Project Title:
SEATTLE NATIONAL GUARD ARMORY

Sheet Contents: FLOOR PLAN, REFLECTED CEILING PLAN, SECTIONS, DETAILS

Sheet Contents:
KITCHEN POWER & LIGHTING PLANS

GENERAL NOTE:
SHEETS RK. 1 & RK. 2 FORM PART OF CHANGE ORDER NO. 1 - REVISION TO THE KITCHEN EQUIPMENT DINGS. DATED 5/11/73.

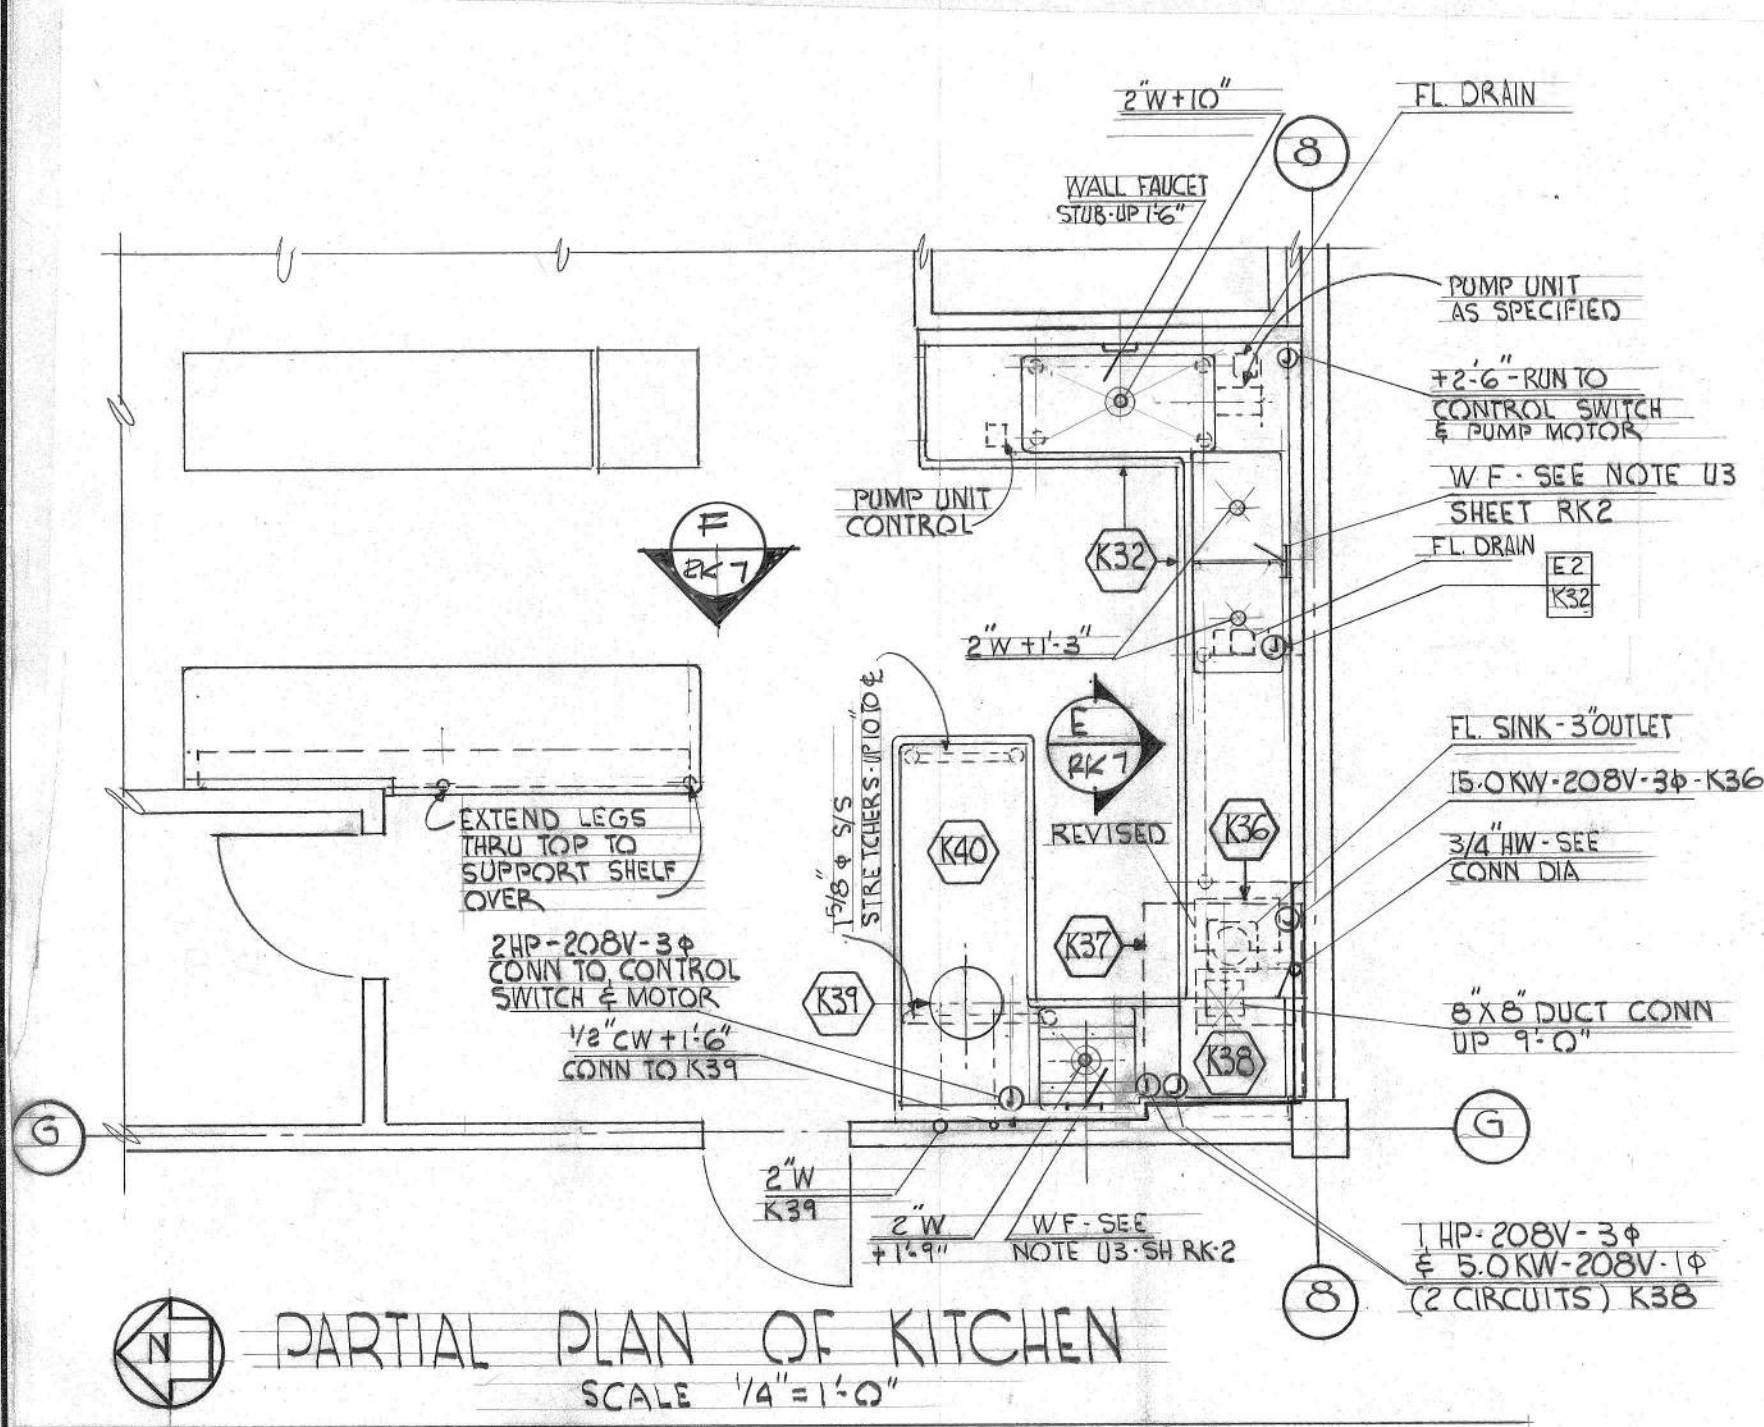
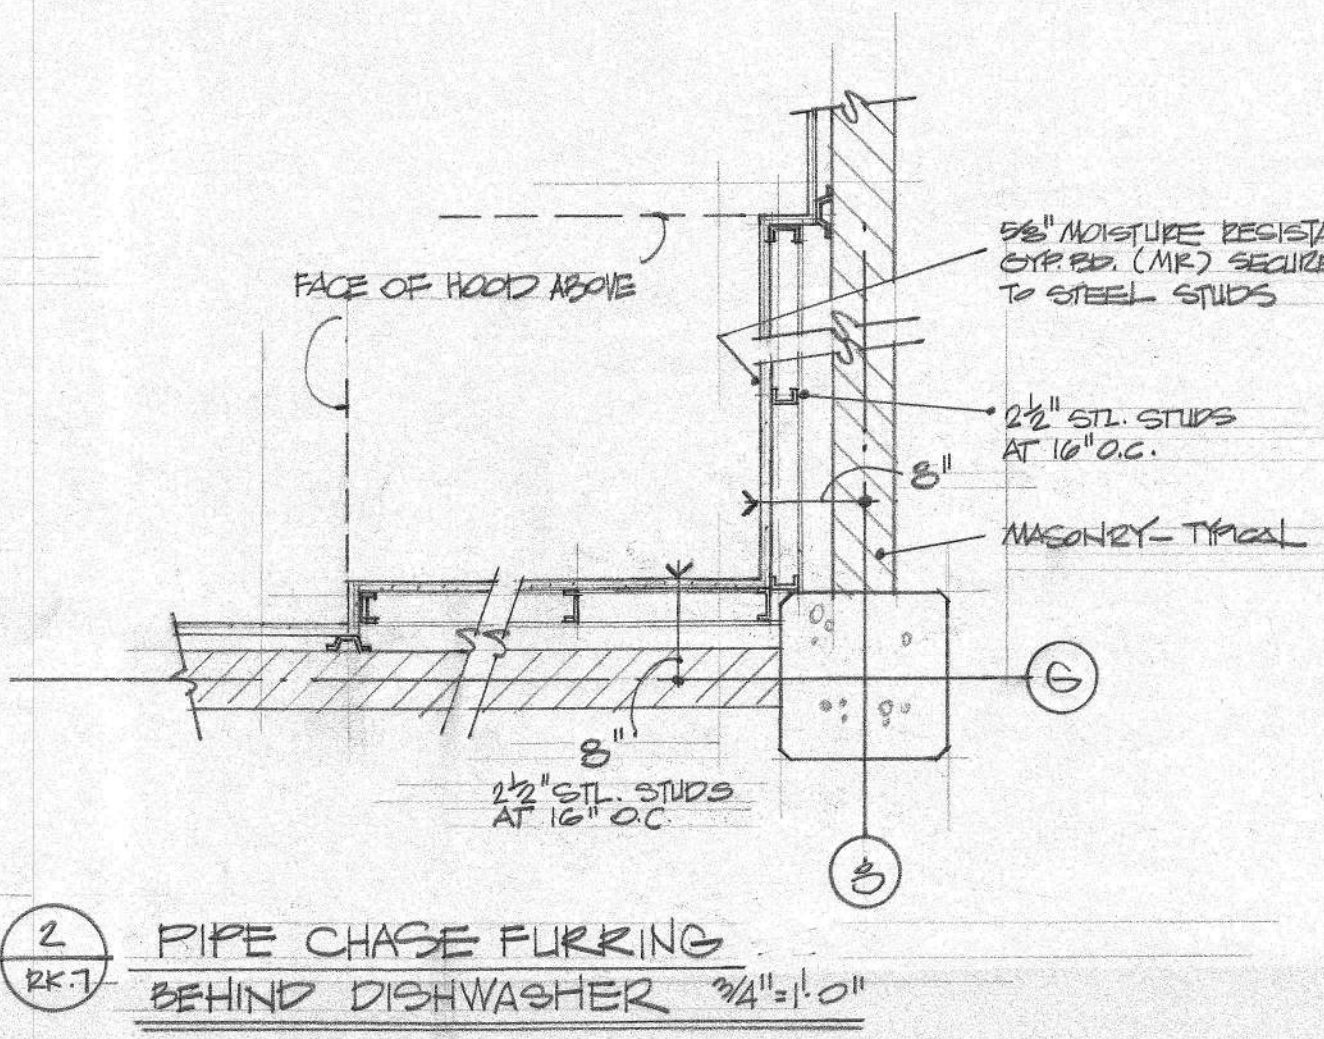
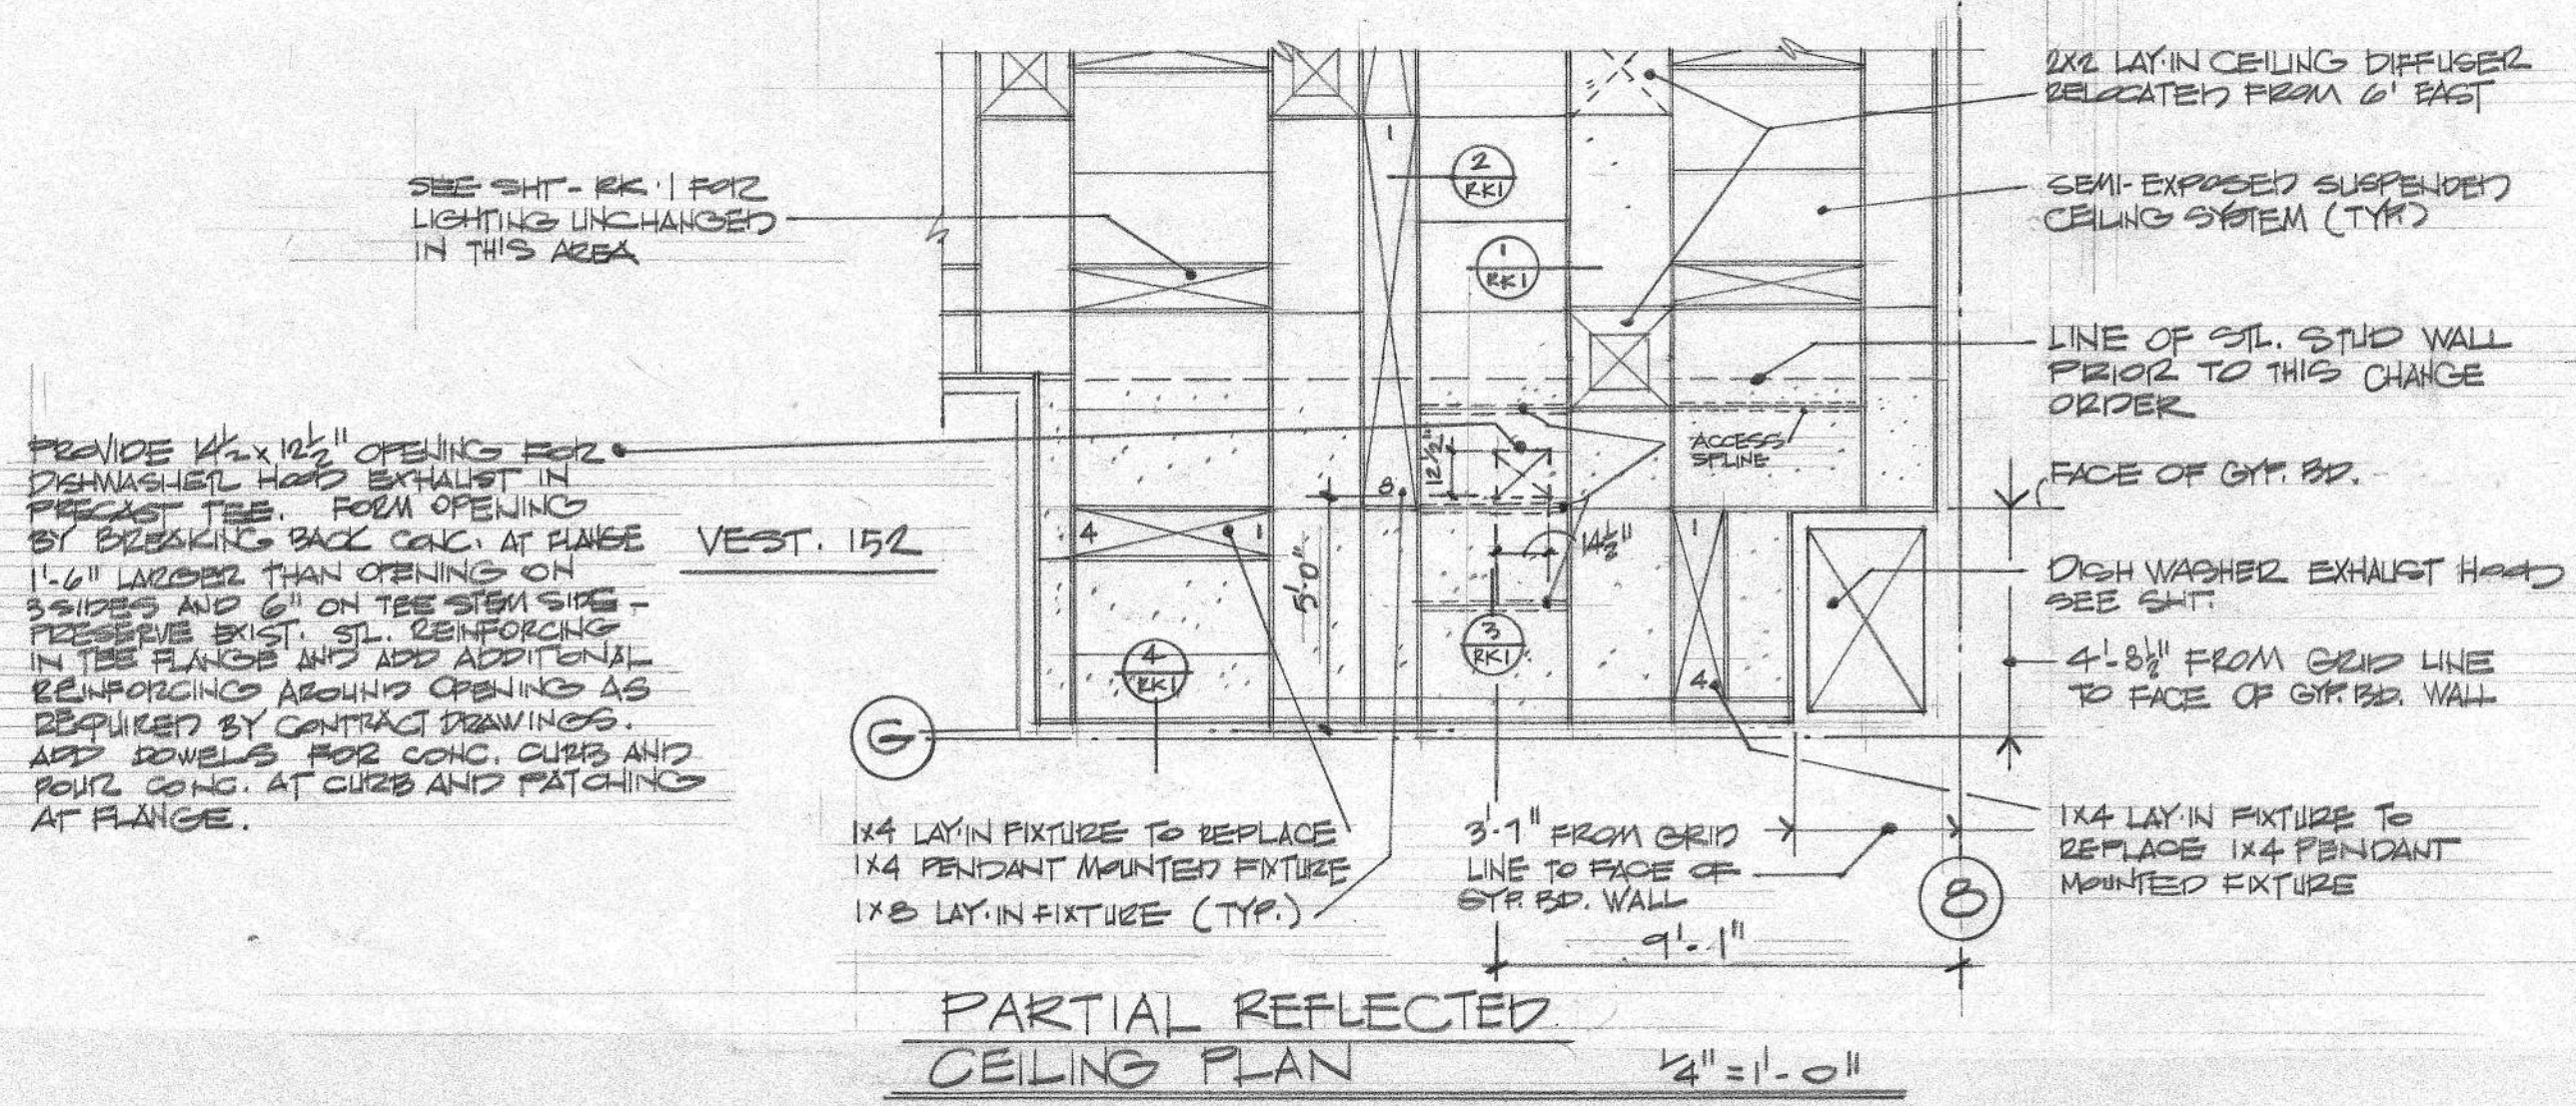
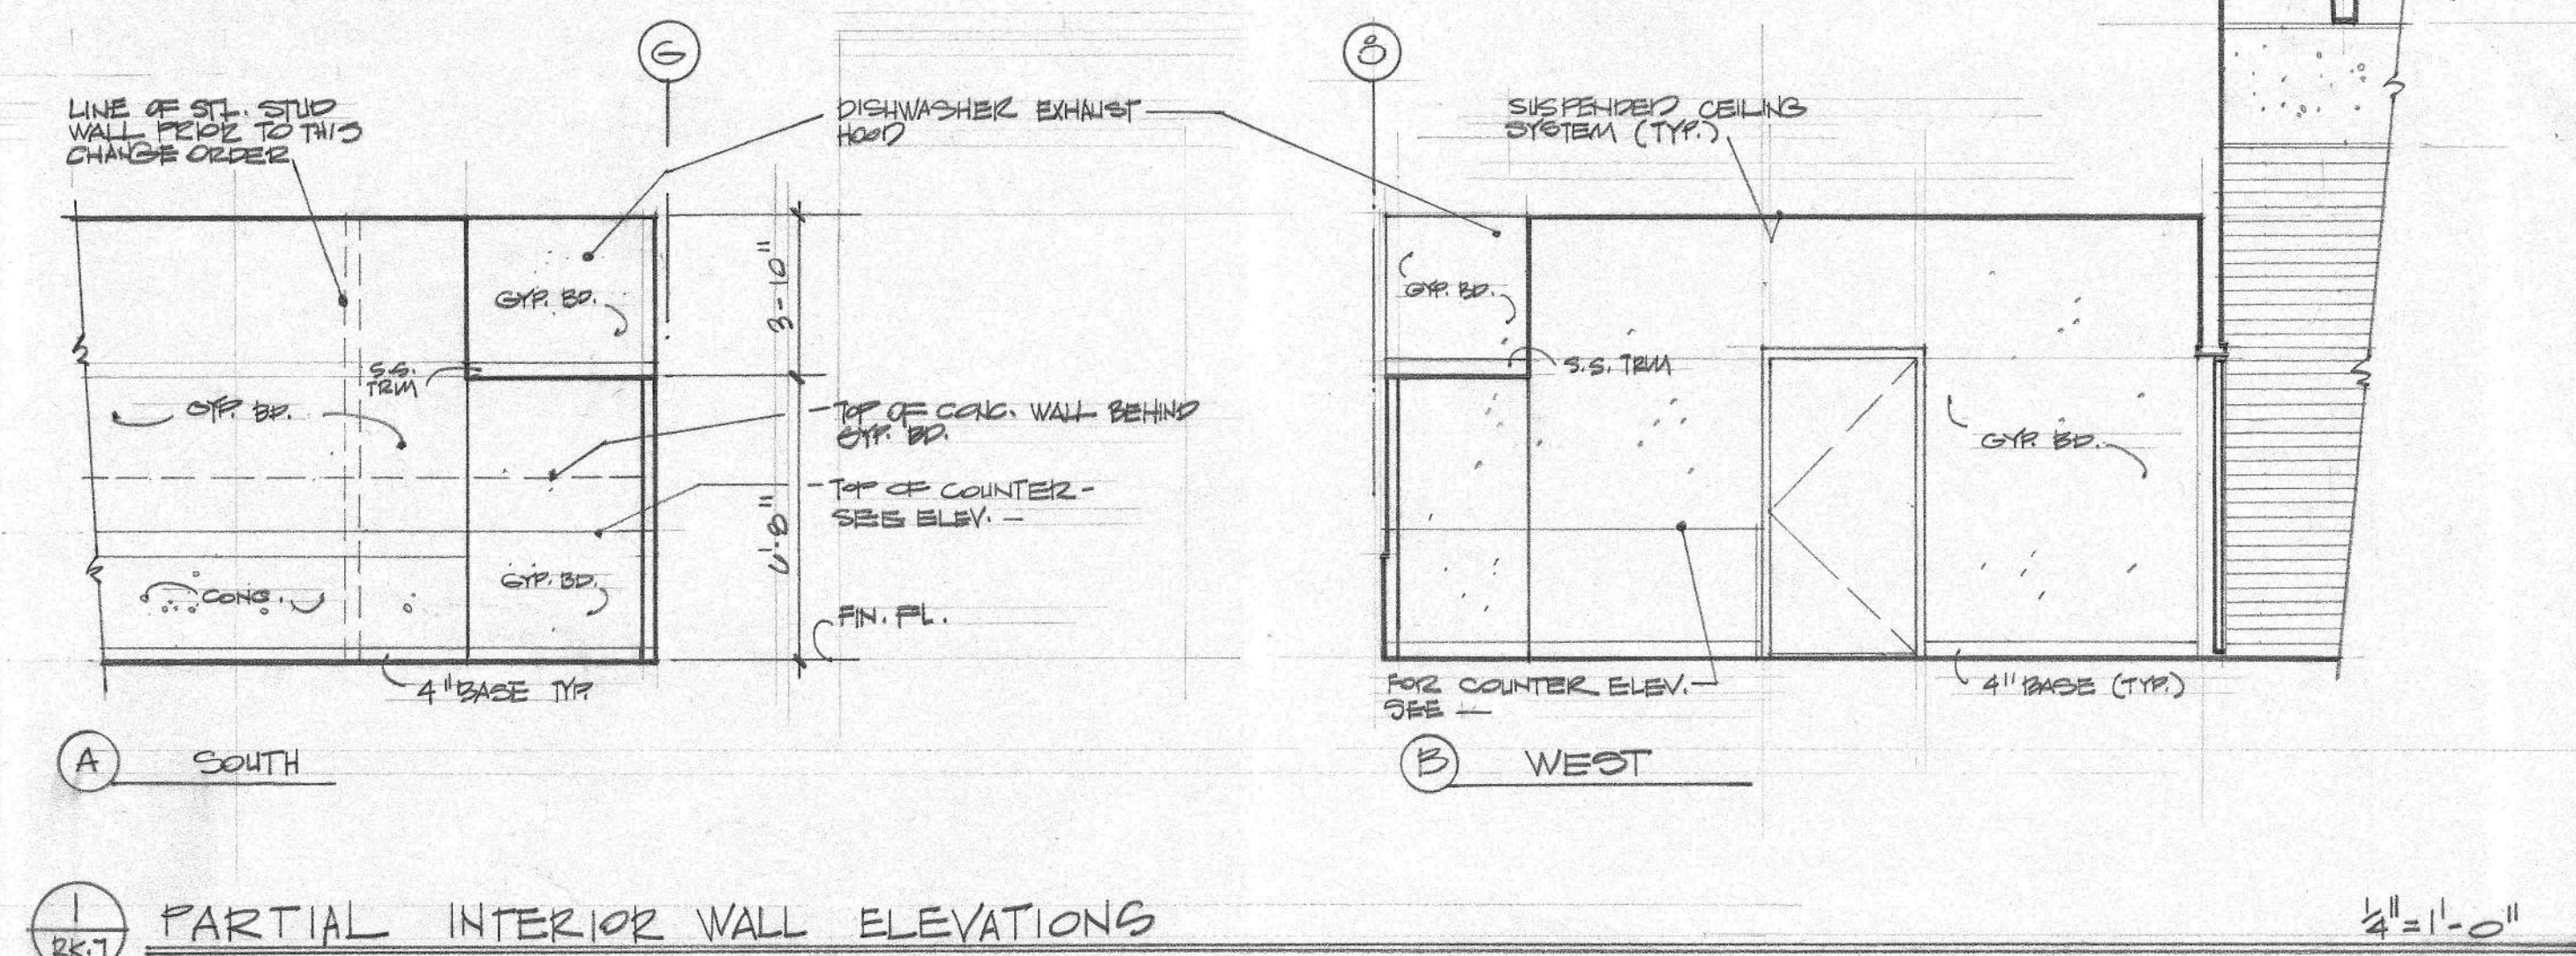
- NOTES:
1. REVISE KITCHEN EQUIPMENT POWER & LIGHTING LAYOUT AS SHOWN.
 2. RE-LOCATE PANEL "IKK" AS SHOWN & PROVIDE CKT. BREAKERS AS FOLLOWS:
(20) 20A-1P KITCHEN EQUIP. REC. & SPARE 120V.
(1) 30A-1P K1 FREEZER 120V
(1) 40A-1P K30 WALK-IN REFER. 120V
(1) 40A-2P K6 HOT FOOD CTR. 208V-1 Ø
(2) 30A-2P RECEPTACLES 120/208V-1 Ø, 3P -4W
(1) 20A-2P K2 DISPOSER 3HP 208V-3 Ø
(1) 30A-3P K32 BOOSTER 208V-3 Ø
(6) 1P SPACES
(1) 2P SPACE
(NO CHANGE TO PANEL FEEDER SIZE)
 3. ELECTRICAL CONTRACTOR SHALL MAKE ALL FINAL CONNECTIONS TO KITCHEN EQUIPMENT & PROVIDE ALL REQUIRED DISCONNECTS.
 4. REFER TO KITCHEN ROUGH-IN PLAN FOR EXACT LOCATION OF ALL OUTLETS.
 5. REFER TO CONTRACT DOCUMENTS & SPECIFICATIONS FOR ADDITIONAL INFORMATION & REQUIREMENTS.
 6. FROM PANEL "IKK" STUB (4) 1" C.O. INTO FURRED CEILING SPACE & CAP.
